Planning Commission Minutes

March 11, 2025 REGULAR MEETING Minutes

PLANNING ACTION: PA-T2-2024-00053

SUBJECT PROPERTY: 231 Granite Street

image 1 - PROPOSED NORTH EAST ELEVATION

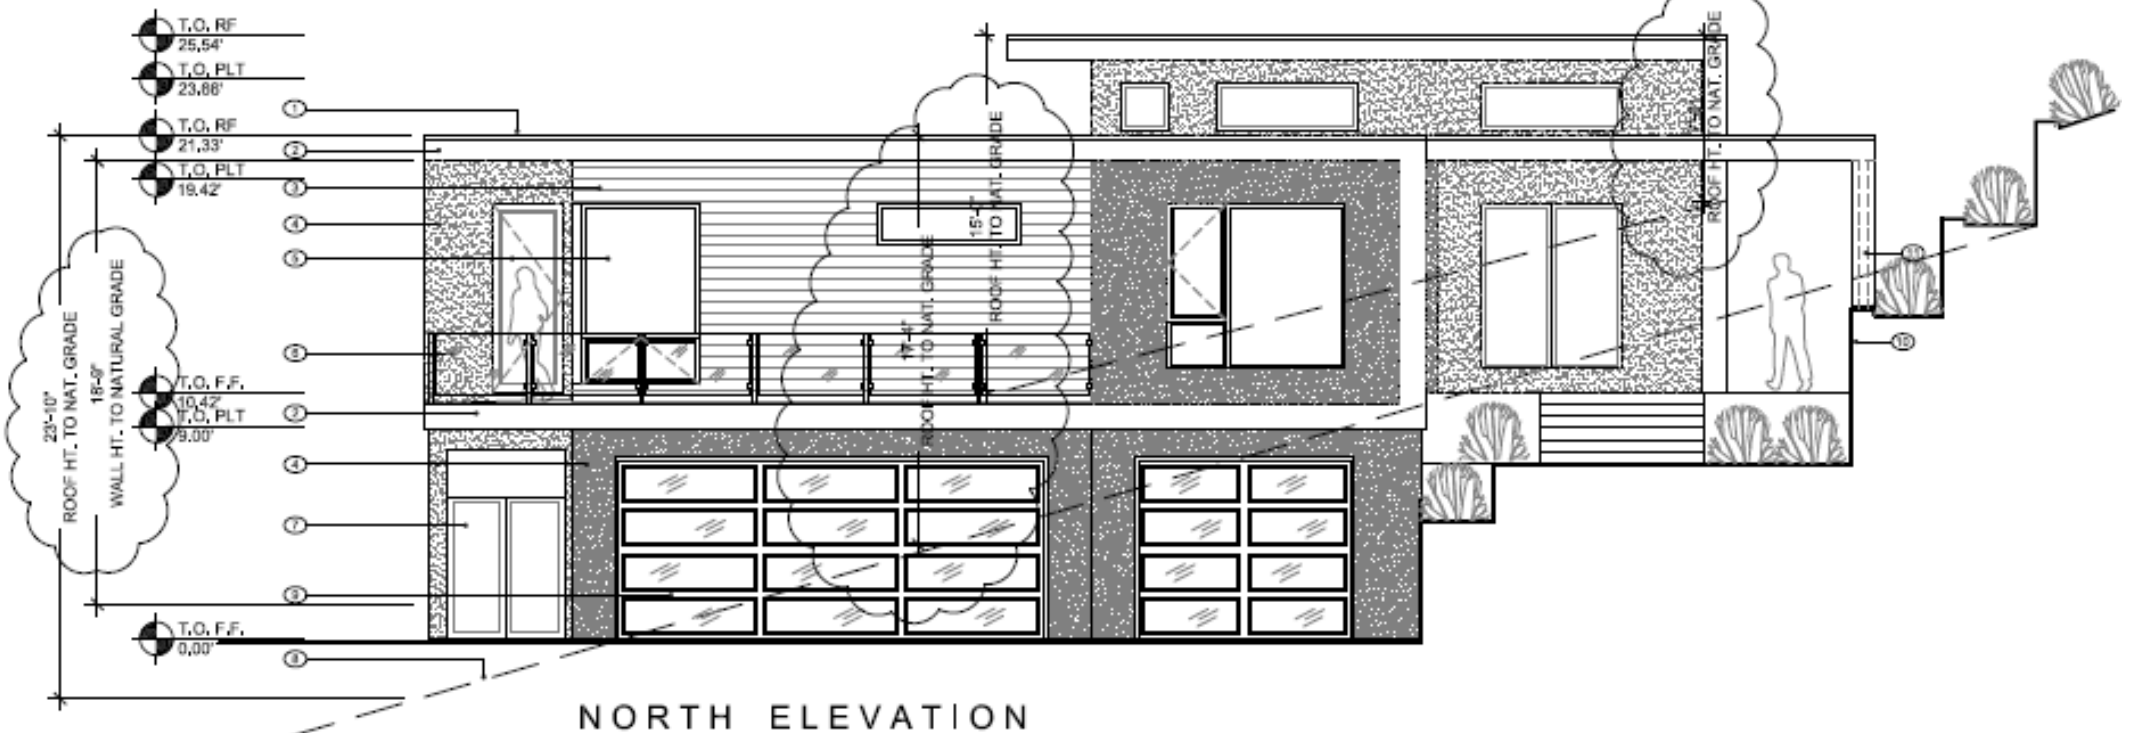
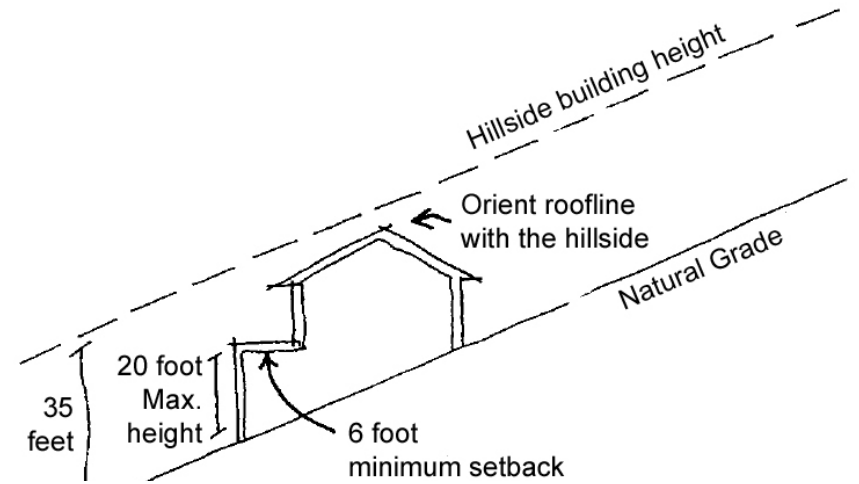
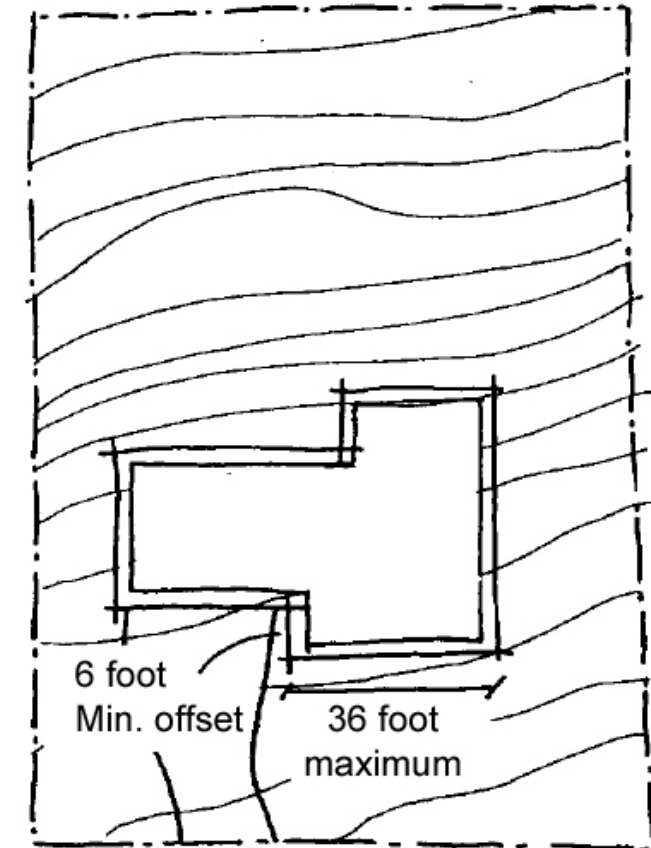
- The standards require that downhill building walls greater than 20 feet provide a six-foot step-back. As proposed, the eastern façade wall is 26 feet high without the required six-foot step-back. (AMC 18.3.10.090.E.2.c).

- Continuous horizontal building planes greater than 36 feet in length are required to include at least a six-foot off-set. The applicant proposes longer planes without the requisite six-foot off-set. (AMC 18.3.10.090.E.2.d..
- The Eastern downhill horizontal building plane is 83-feet long with 5 different planes, as follows:
 - The first 22'3" has a 6-foot offset
 - The next section is 16-feet long with a 6-foot offset on the north side (and 4-feet on the South side)
 - The next section is 16'9" followed by a 22'3" section
 - The next section's southern half **requires an exception** for 2 different sections:
 - One section is 39-feet long with a 4-foot offset and;
 - The other section is 44-feet with a 5-foot offset.

Pages A1.0 & A1.1 from applicant's submittals (accidentally omitted)

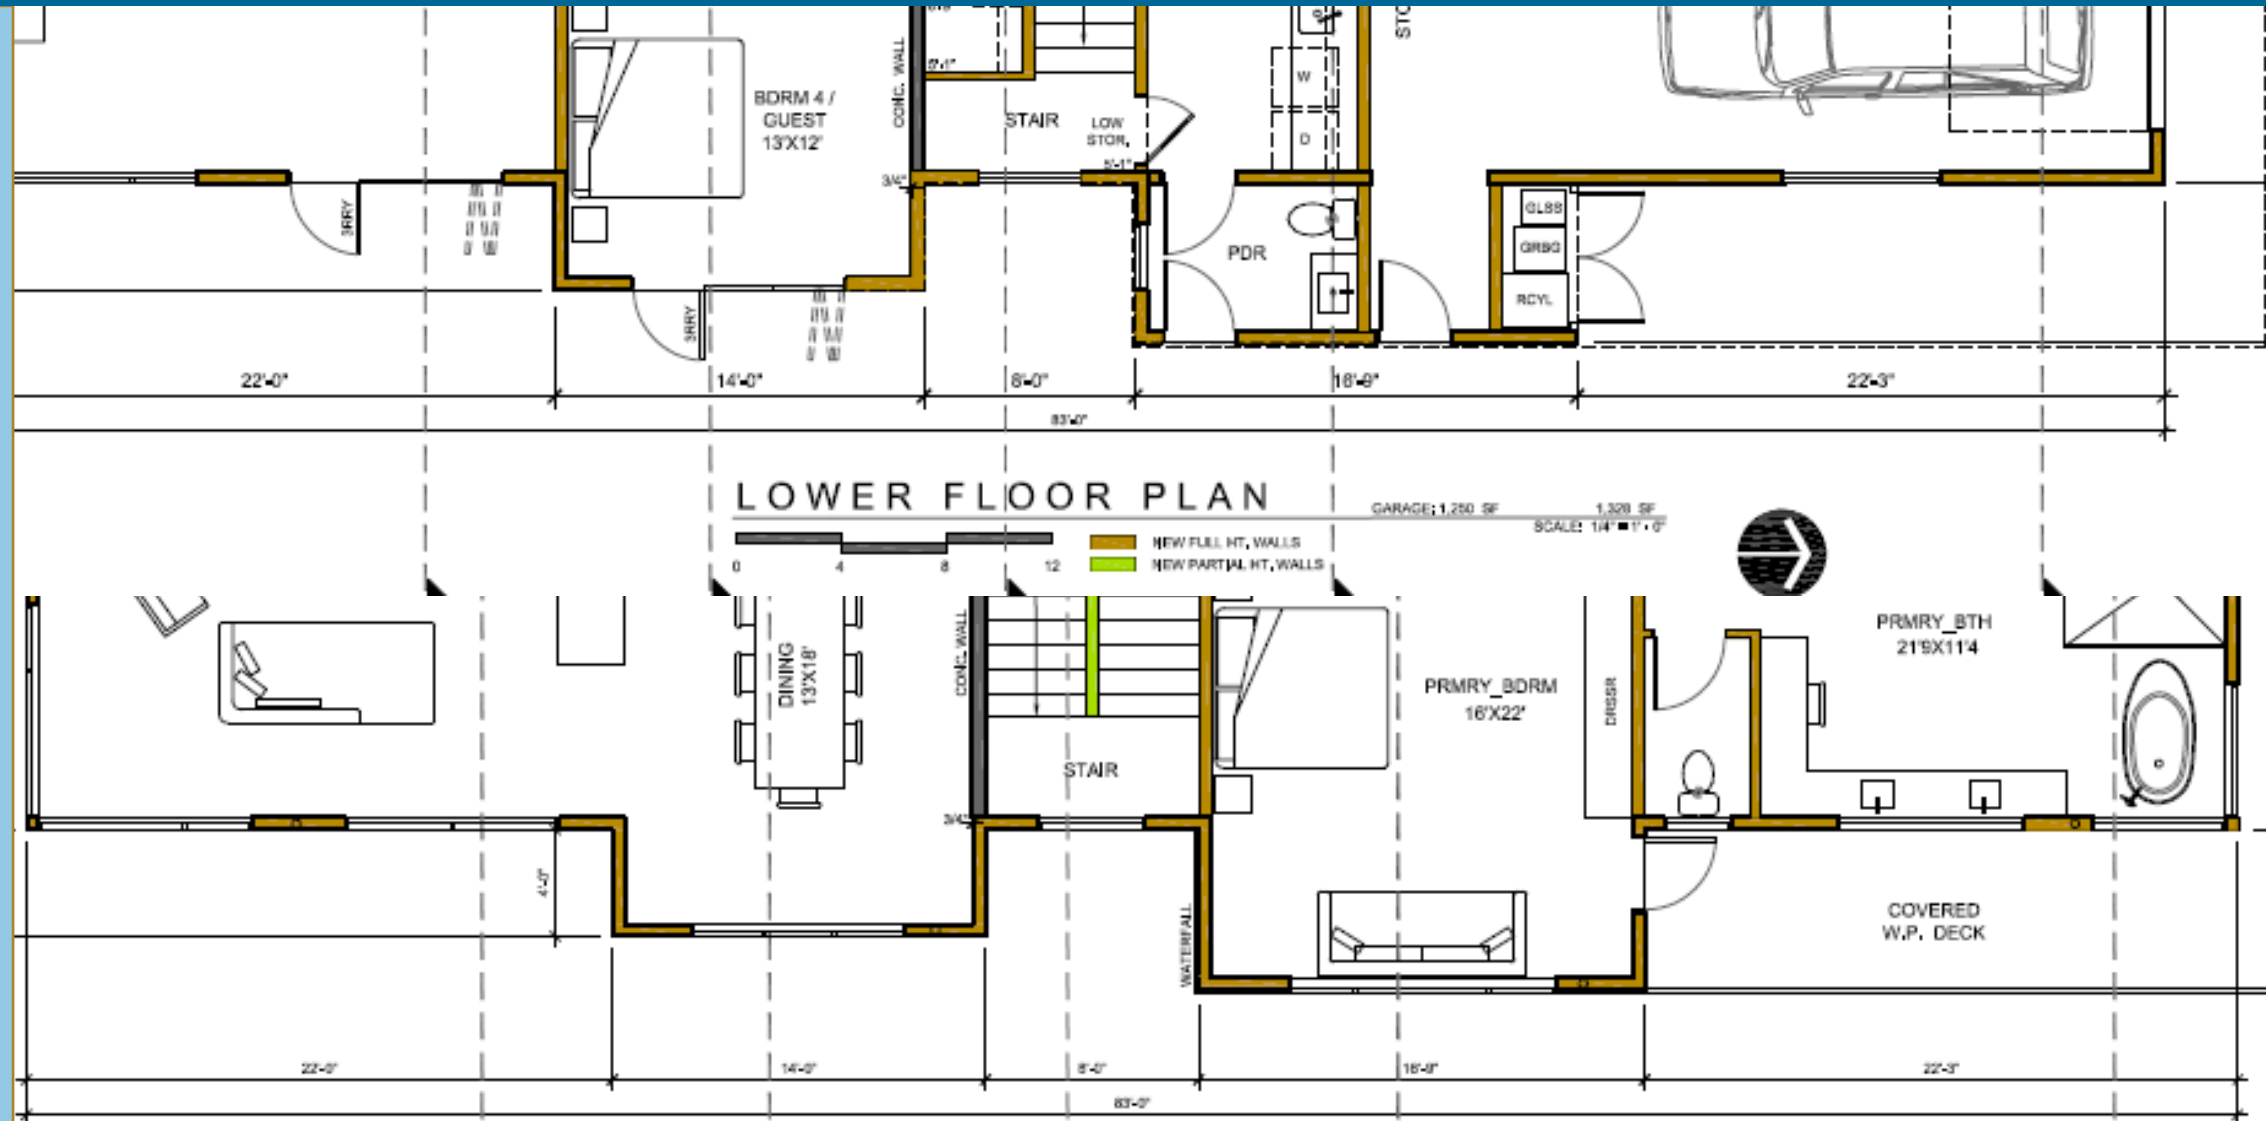
- 4 pages of the applicant's submittals were unintentionally omitted from the packet materials & online posting as follows:
 - o 2 pages for floor plan (A1.0 & A1.1)
 - o 1 page for West & South Elevations (A2.2)
 - o And a site plan that shows the distance from the nearest downhill fire hydrant to the proposed structure

Proposed Driveway Variance:

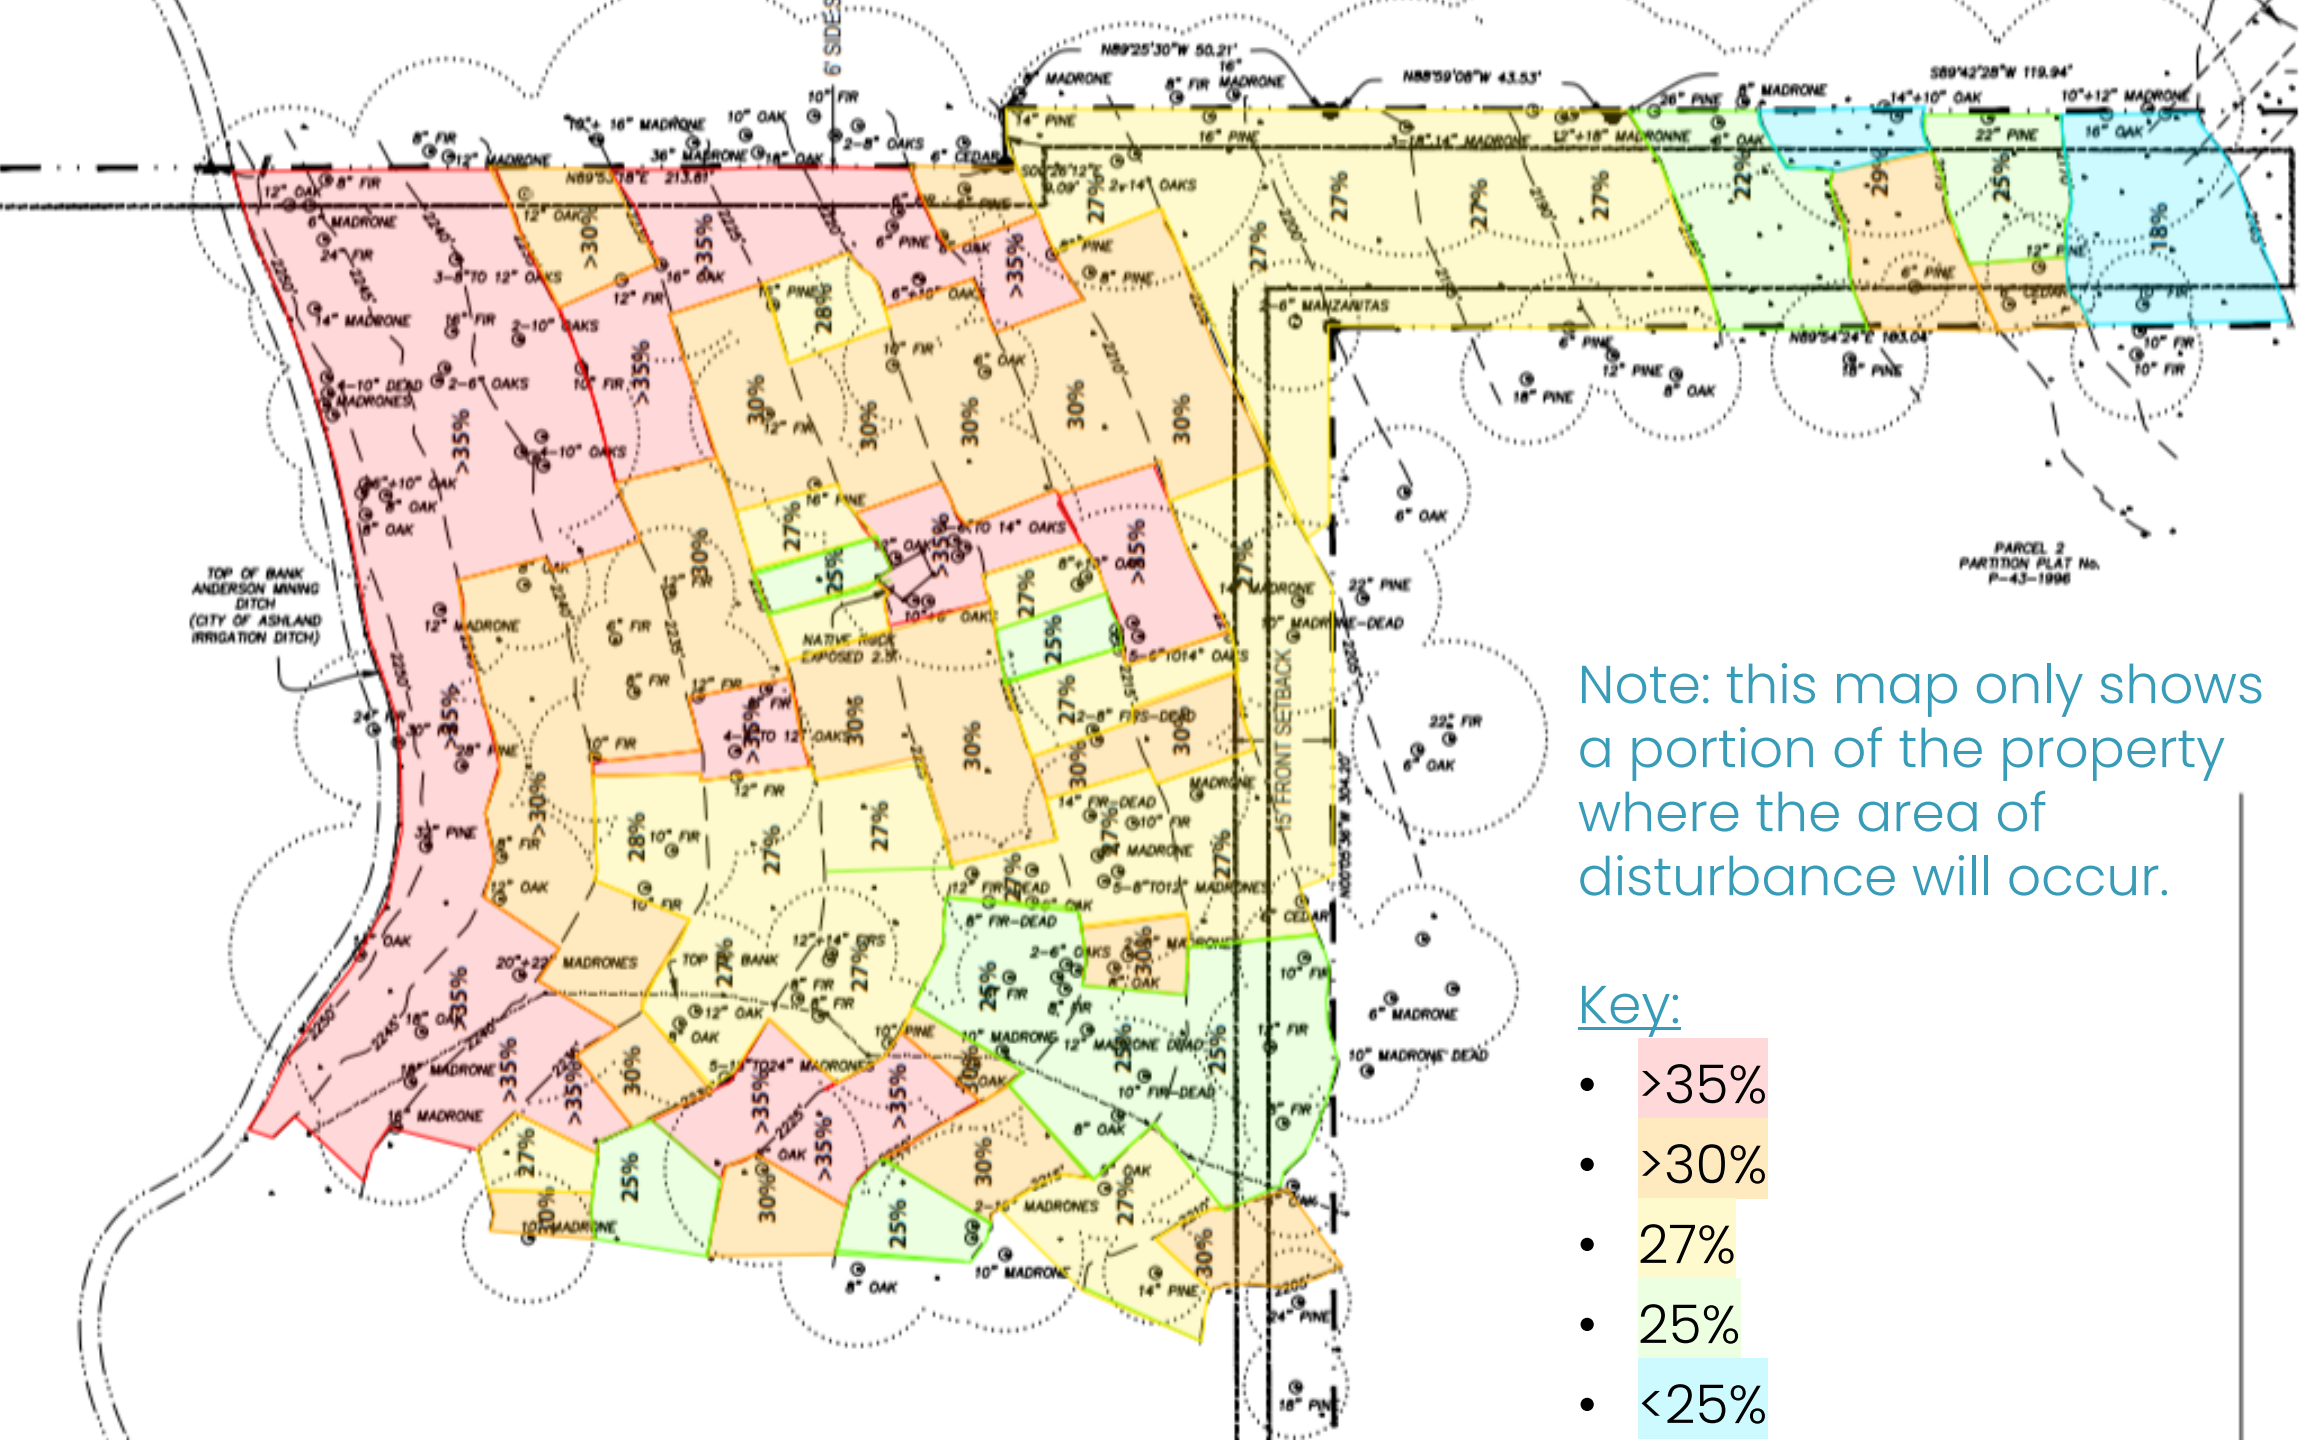
A request for a Type 2 Variance to the flag drive standards. The allowed maximum grade of a flag drive is 15% without a variance, or 15-18% for a Type 1 Variance. Any request for 10% or more from the allowance is a Type 2 variance.

- **Add condition #14:** "Prior to submittal of building permit, applicant must provide a surveyor's map that confirms the driveway grade does not exceed 23% and that the length of the portion of the driveway in 35% does not exceed 200 feet."
